**Appln No. 10/004,458
Amdt date August 30, 2005
Reply to Office action of July 1, 2005**

Amendments to the Drawings:

REMARKS/ARGUMENTS

Fig. 5A

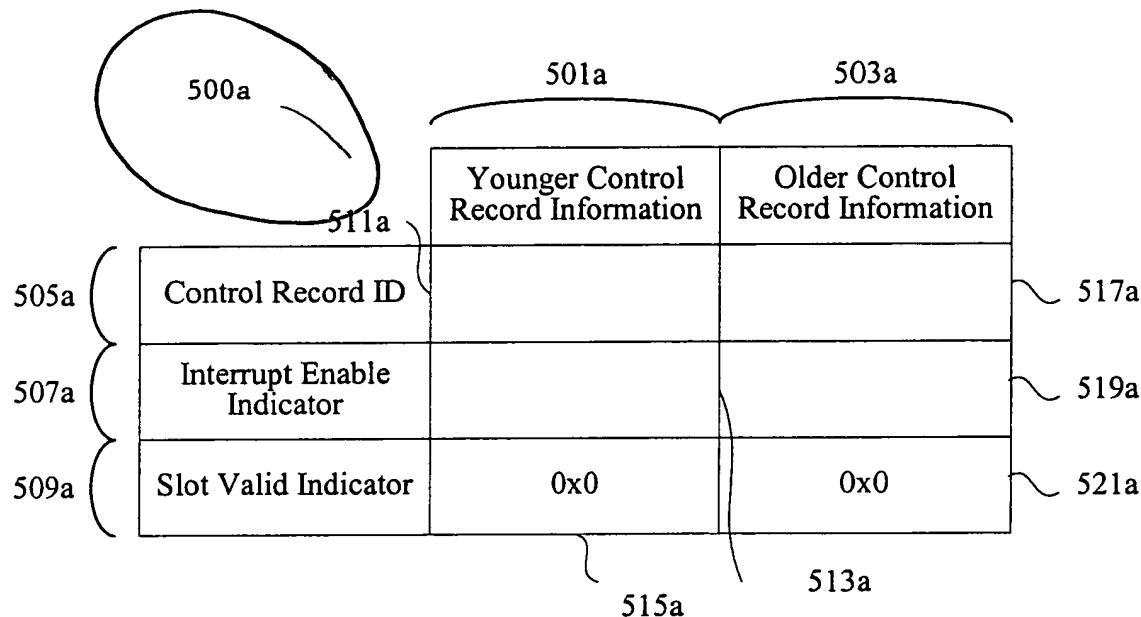
The attached 2 sheets of drawings includes changes to Figs. 5A, 5B, and 5C. The attached 2 replacement sheets, which includes Figs. 5A, 5B, and 5C, replaces the original 2 sheets including Fig. 5A, 5B, and 5C.

The drawings are objected to as failing to comply with 37 CFR 1.84(p) (5). FIGs. 5A, 5B, and 5C are amended to add the reference numerals 500a, 500b and 500c mentioned in the specification for the history buffer. The specification is amended to add reference numerals 309 and 331 in the related paragraph. In view of the amendments to the drawings and related amendments to the specification, it is respectfully requested that the above objections be withdrawn. The specification is also amended to correct typographical errors. No new matter is added.
